Re: Clean Copies
Addition of Ground Water
Monitoring Well S-3-GW
Savage Services Corporation
Savage Coal Terminal
C/007/0022, Task ID #4151

Permittee: Savage Services Corporation
Mine: Savage Coal Terminal **Permit Number:** C/007/0022
Title: Addition of Ground Water Monitoring Well - Clean Copies

Addition of a ground water monitoring well.

SAVAGE COAL TERMINAL
 WATER MONITORING LOCATION MAP

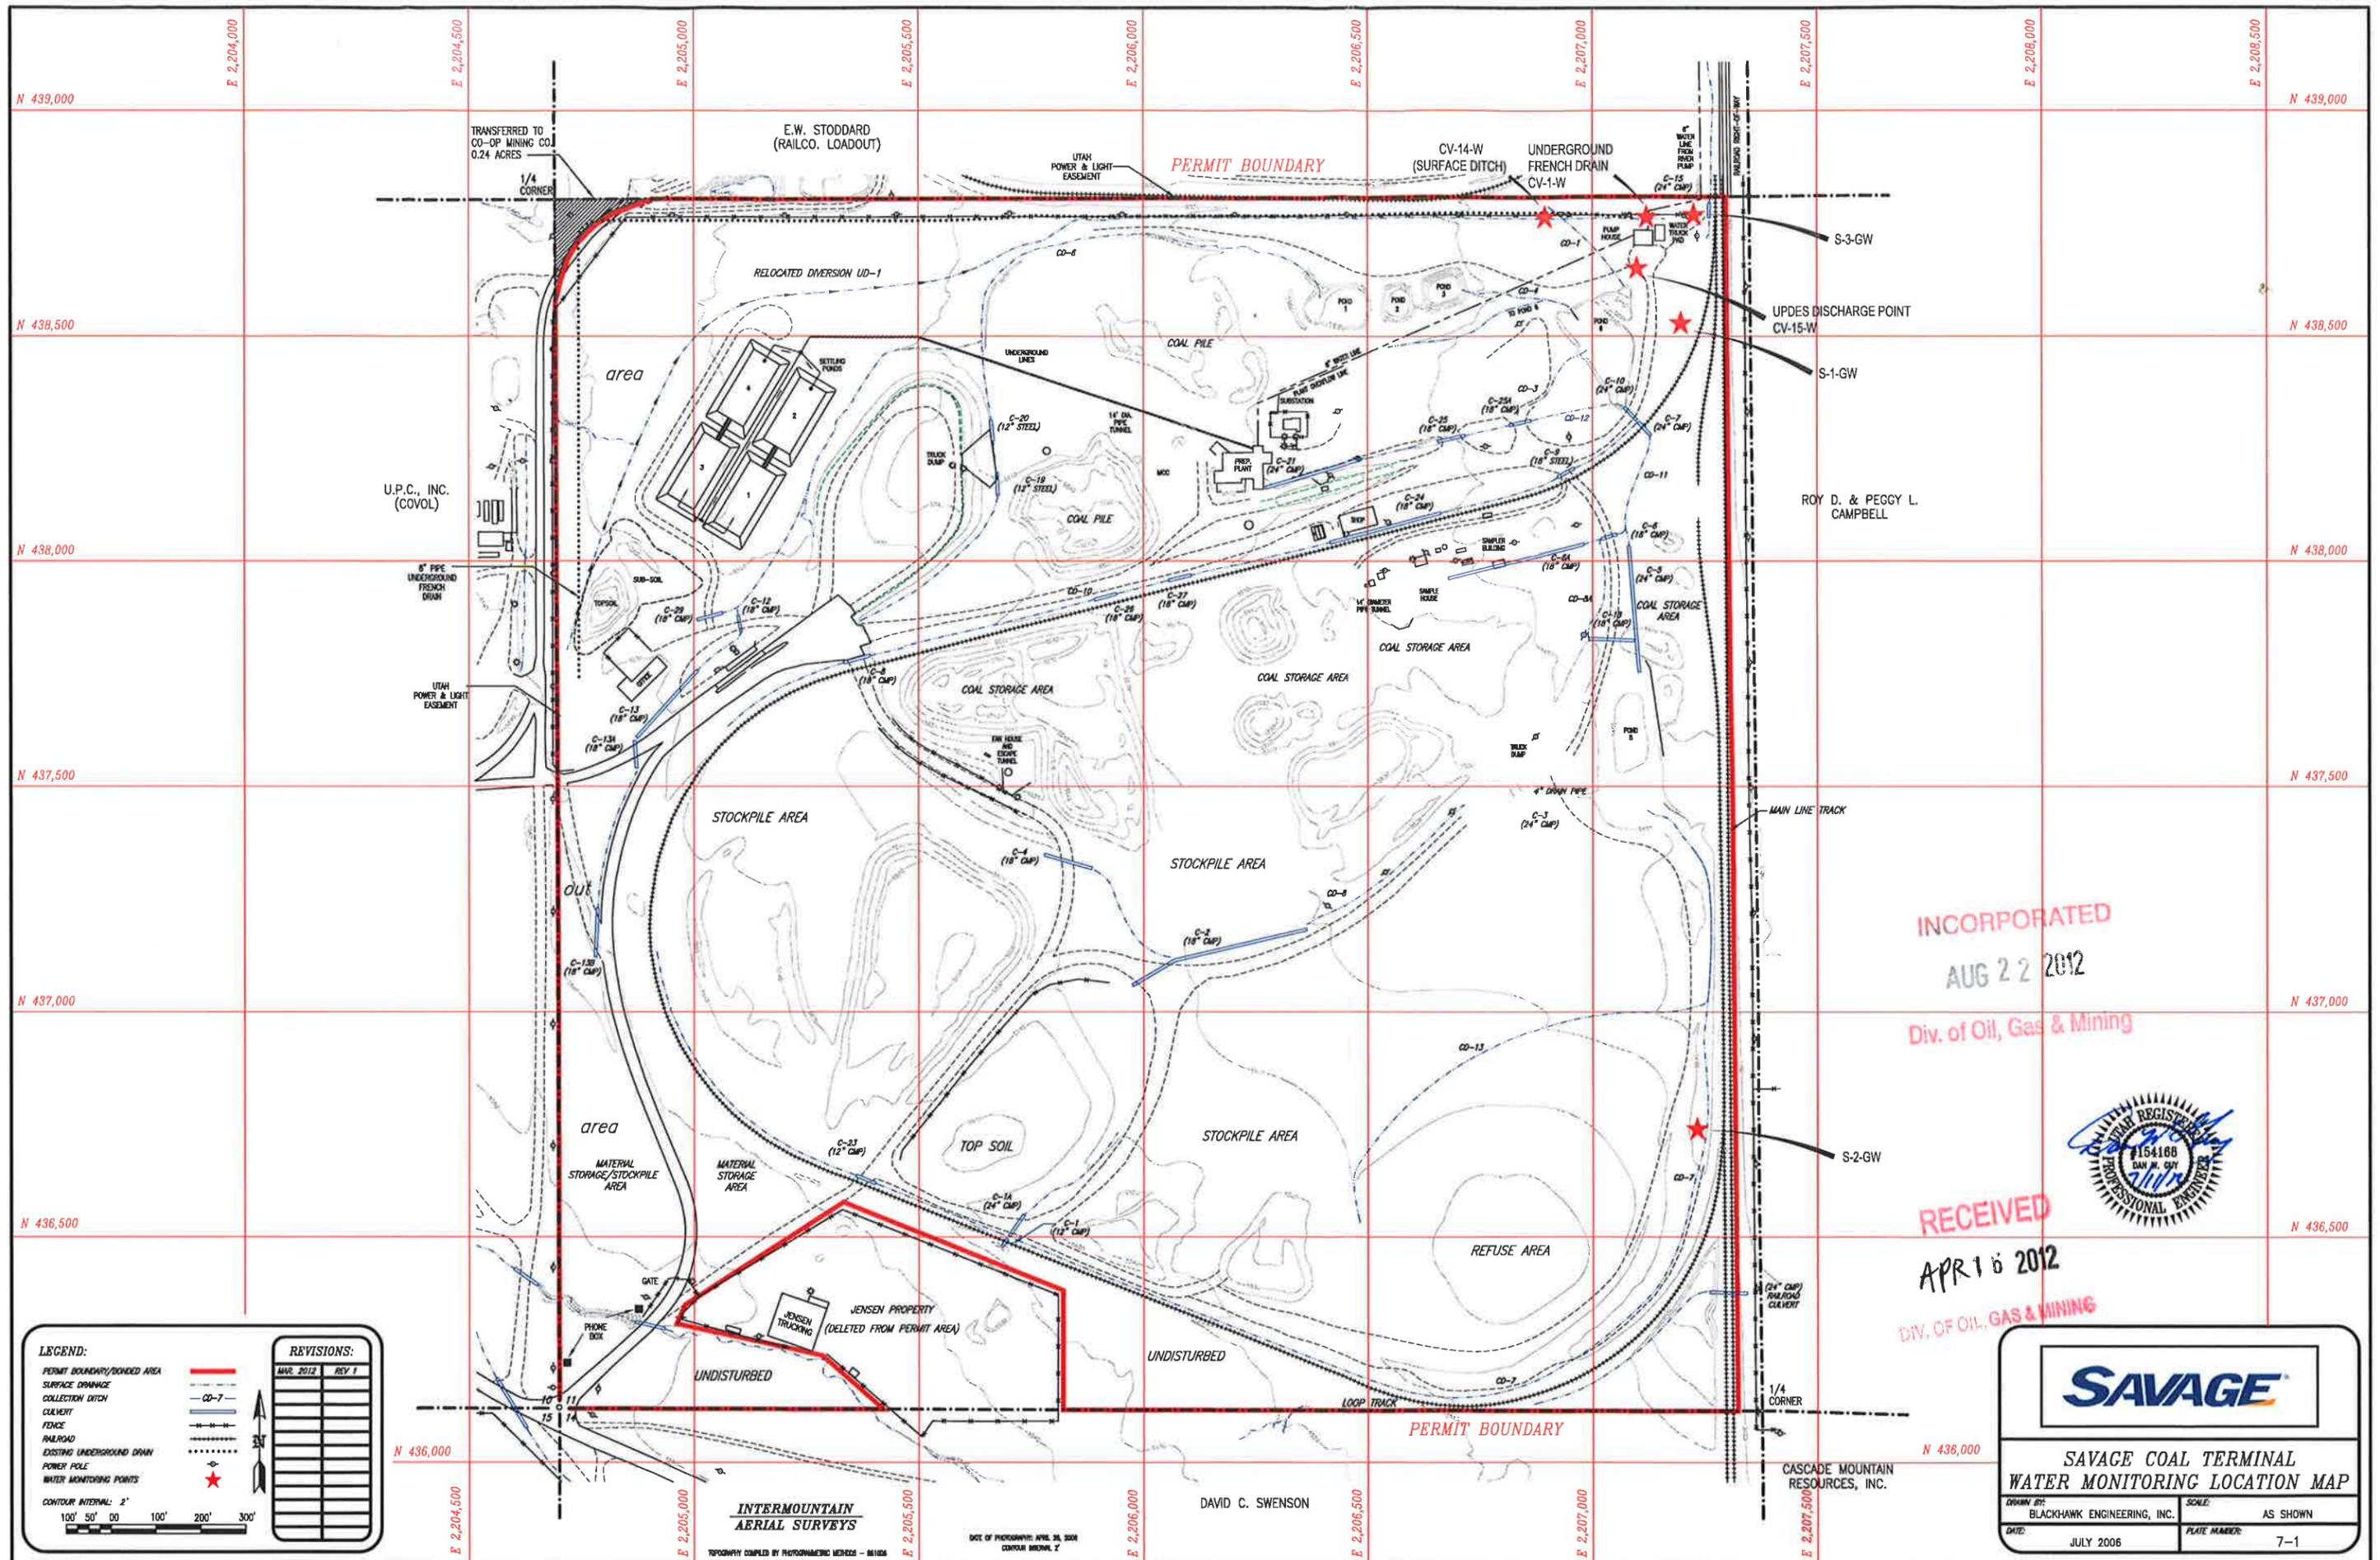
In 2009, 2 new ground monitoring wells were installed as required by the Division. These wells were designated S-1-GW and S-2-GW, and were placed near the northeast corner of the site and below (east) of the refuse pile respectively. A new well (S-3-GW) was added east of the pumphouse in June 2012. Although originally dry, it is hoped this well will provide some additional data in the future.
